Safety Evaluation

Florida Power and Light Company
Turkey Point Units 3 and 4
Docket Nos. 50-250 and 50-251

7.0 Technical Specification Changes

Figure 1

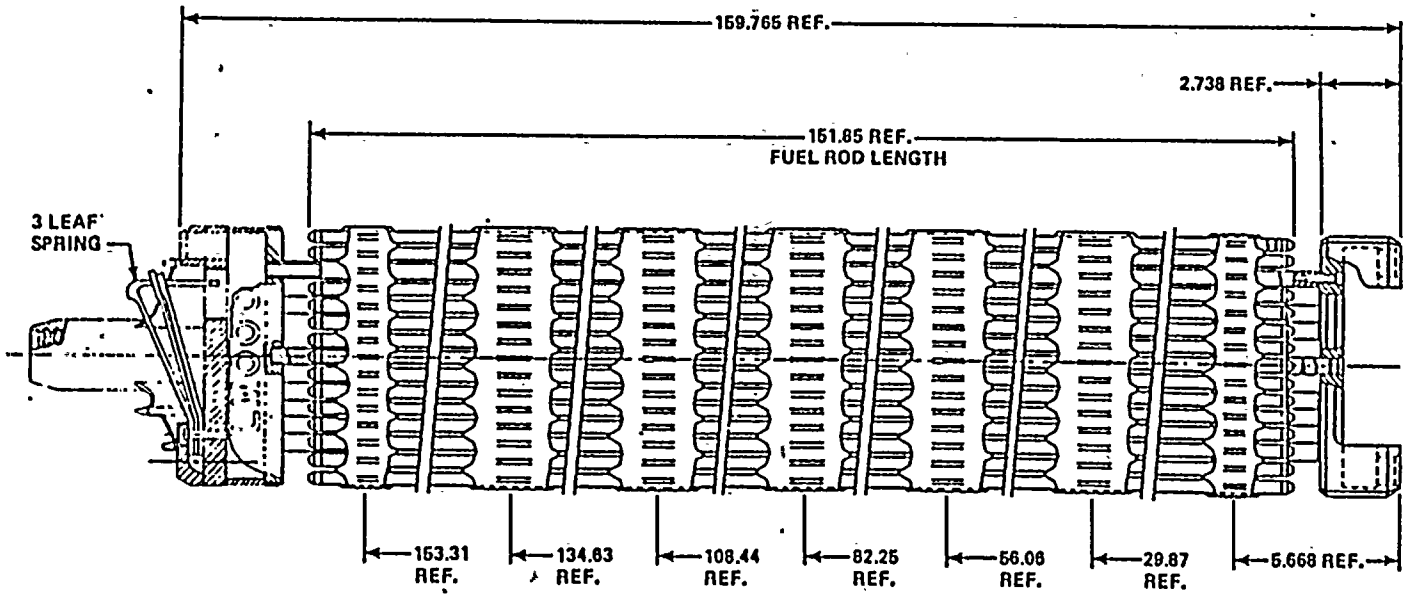
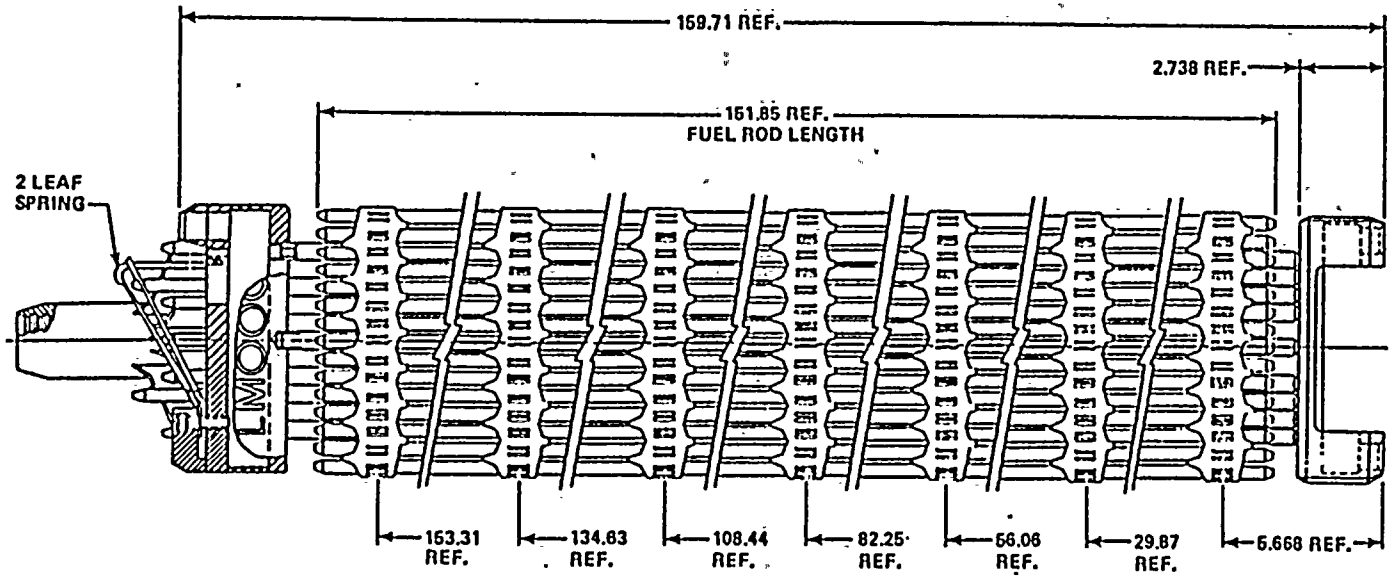
The OFAs have been designed to be compatible with the LOPAR assemblies, reactor internals interfaces, and fuel handling and refueling equipment. Figure 1 presents a comparison of the OFA and LOPAR fuel assembly. The grid elevations for the two assembly designs match, minimizing mechanical and hydraulic interaction. The assembly envelopes, fuel rod design/dimensions, and the top and bottom Inconel grids are the same.

The five intermediate 15x15 OFA Zircaloy grids have thicker and wider straps than the 15x15 LOPAR Inconel grids to compensate for the difference in material strength properties. Impact tests that have been performed at 600°F to obtain the dynamic strength data verify that the Zircaloy grid strength data at reactor operating conditions is structurally acceptable. The 15x15 OFA Zircaloy grid design has approximately 7 percent less crush strength than the 15x15 Inconel grid design.

The 15x15 OFA guide thimbles are similar in design to their counterparts in the LOPAR fuel assemblies except for 13 mil ID and OD reduction in the guide thimble above the dashpot. The reduction in OFA thimble diameter is due to the use of the thicker Zircaloy grid straps. The new design continues to provide an adequate nominal diametral clearance for control rods as well as other core components. Due to the reduced clearance, the rod drop time to the dashpot for accident analyses has conservatively been determined to increase from 1.8 seconds for the LOPAR assembly to 2.4 seconds for the OFA. The increase in rod drop time required accident reanalyses as described in Section 6.0.

The OFA has about a 4.5 percent increase in hydraulic resistance to flow compared to a LOPAR assembly, primarily due to the thicker and wider OFA Zircaloy grid straps. This results in an increased OFA lift force and requires the use of 3-leaf holddown springs in the top nozzle instead of the LOPAR assembly 2-leaf springs (see Figure 1). The 3-leaf spring has the same height and provides additional holddown force margin when compared to the LOPAR 2-leaf spring. The 3-leaf spring design has been successfully used in the 17x17 OFA demonstration program and other 15x15 LOPAR assemblies. The change to the 3-leaf spring is fully compatible with the LOPAR assembly and the handling tools at the Turkey Point plants. The 15x15 OFA bottom nozzle has similar design features as the LOPAR assembly bottom nozzle. The OFA bottom nozzle design has a reconstitutable feature which allows it to be easily removed. A locking cup is used to lock the thimble screw of a guide thimble tube in place, instead of the lockwire as used for the standard LOPAR nozzle design. The reconstitutable nozzle design facilitates remote removal of the bottom nozzle and relocking of thimble screws as the bottom nozzle is reattached.
